**RE: Addendum to Vapor Interim Remedial Measure Work Plan
Vapor Intrusion Investigation – Phase II Program
DuPont Pompton Lakes Works
Pompton Lakes, New Jersey**

To: David Epps – DuPont, Corporate Remediation Group *cc:* M. Distler – O'Brien & Gere
From: Norma Eichlin – O'Brien & Gere
Re: Vapor Intrusion Investigation – Phase II Program
Addendum to Vapor Interim Remedial Measure Work Plan
DuPont Pompton Lakes Works
Pompton Lakes, New Jersey
File: 3914/43110
Date: October 27, 2009
October 29, 2009 REVISED
November 4, 2009 REVISED

Figure 1
 DuPont Pompton Lakes Works
 Vapor Mitigation Area
 Phase II Sampling Program

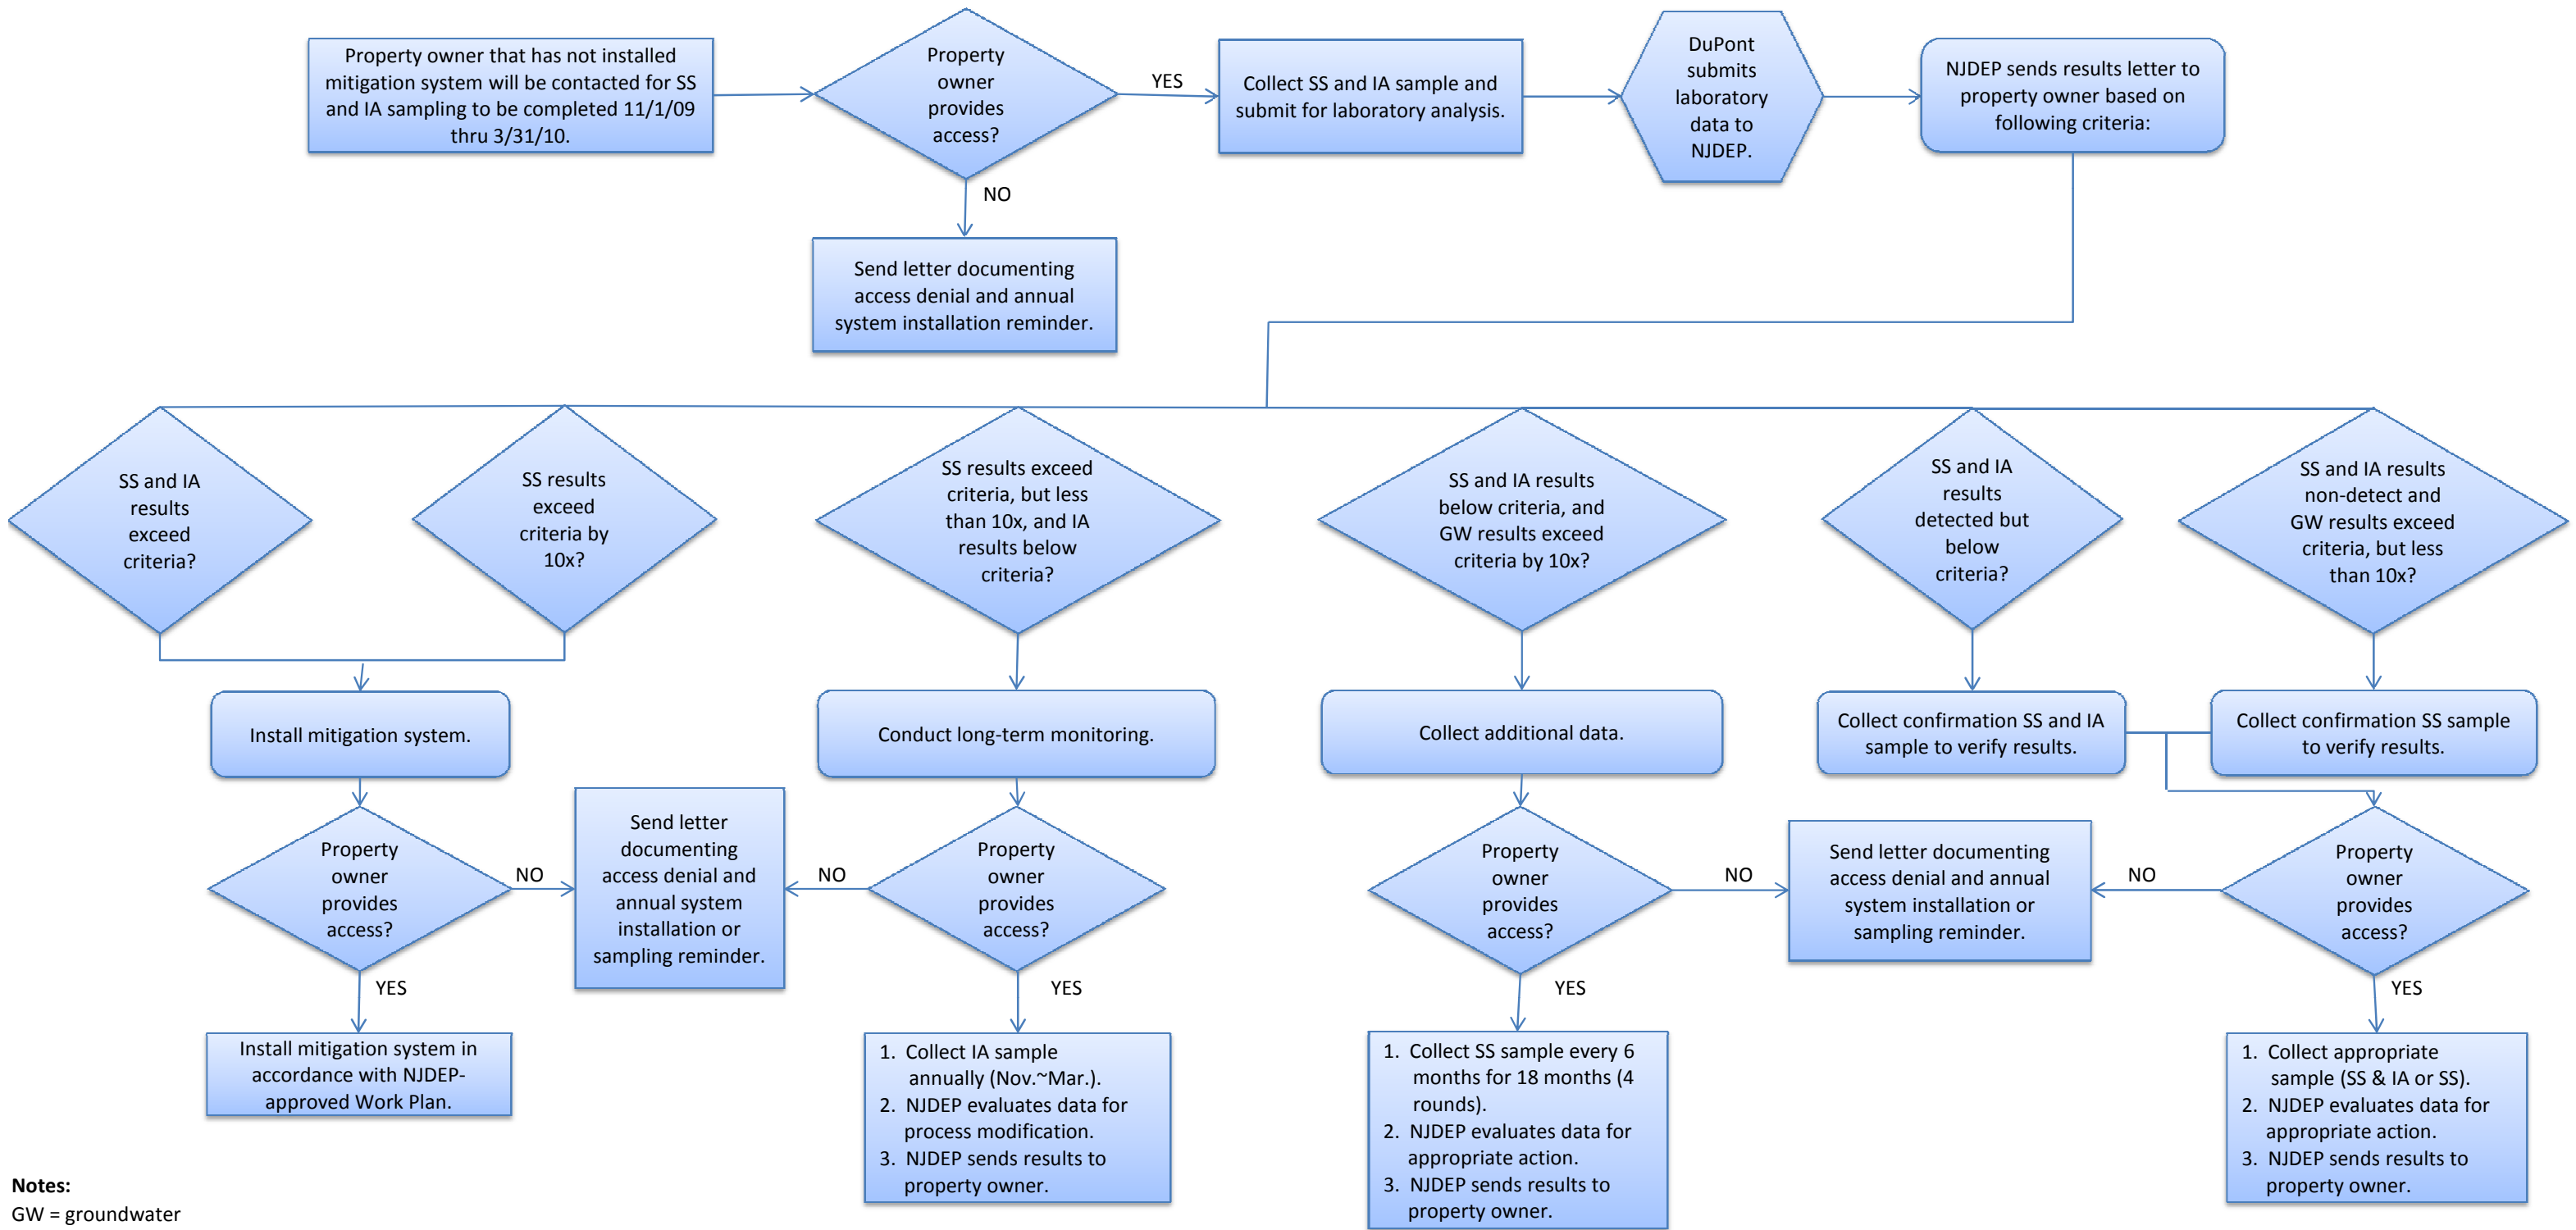
NJDEP has directed DuPont to initiate the next phase of the overall vapor intrusion program which is to conduct sub-slab soil gas and indoor air sampling at properties within the groundwater plume area where systems have not yet been installed. This sampling, as outlined in NJDEP's VIG, is to be conducted during the months of November through March which correlates to a time at which a structure may be under maximum potential depressurization. The decision matrix to be used for data evaluation collected during this program is provided as Figure 1.
